# Proposed Changes to the PCS sync SM

**IEEE P802.3bs 400 Gb/s Ethernet Task Force**

January 2016 Atlanta

Figure 119-13—PCS synchronization state diagram

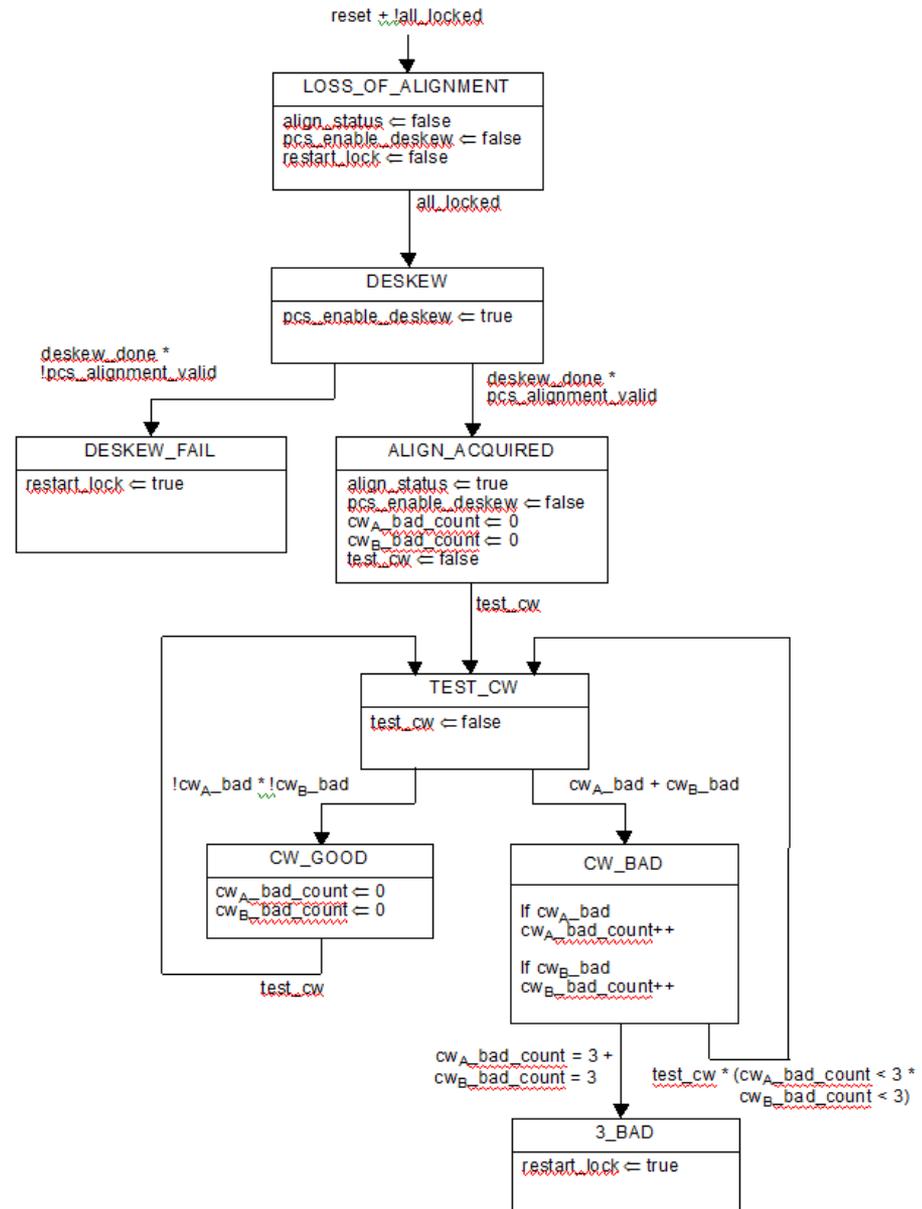
- The current PCS synchronization state machine looks for 3 uncorrectable codewords in a row to declare loss of lock
- We now mux two codewords together, it is not clear in the SM how that is handled, do we declare loss of lock if any 3 are uncorrectable, or just 3 from one codeword (A or B)?
- In sun\_01\_1215\_logic the unlock time is shown assuming 3 consecutive uncorrectable codewords from one codeword (A or B). Due to interleaving, burst errors can create uncorrectable codewords in A and B too easily.
  - Counting 3 blocks from A and B is equal to counting 2 blocks from one FEC decoder which results in too short of an unlock time
- The rest of this shows the proposed changes to clarify this, response for comment #s: 68, 5

### **cw<sub>A</sub>\_bad**

A Boolean variable that is set to true if the Reed-Solomon decoder (see 119.2.5.3) fails to correct the current FEC codeword<sub>A</sub> and is set to false otherwise.

### **cw<sub>B</sub>\_bad**

A Boolean variable that is set to true if the Reed-Solomon decoder (see 119.2.5.3) fails to correct the current FEC codeword<sub>B</sub> and is set to false otherwise.

### **cw<sub>A</sub>\_bad\_count**

Counts the number of consecutive uncorrected FEC codewords for codeword<sub>A</sub>. This counter is set to zero when codeword<sub>A</sub> is received and cw\_bad<sub>A</sub> is false.

### **cw<sub>B</sub>\_bad\_count**

Counts the number of consecutive uncorrected FEC codewords for codeword<sub>B</sub>. This counter is set to zero when codeword<sub>B</sub> is received and cw\_bad<sub>B</sub> is false.
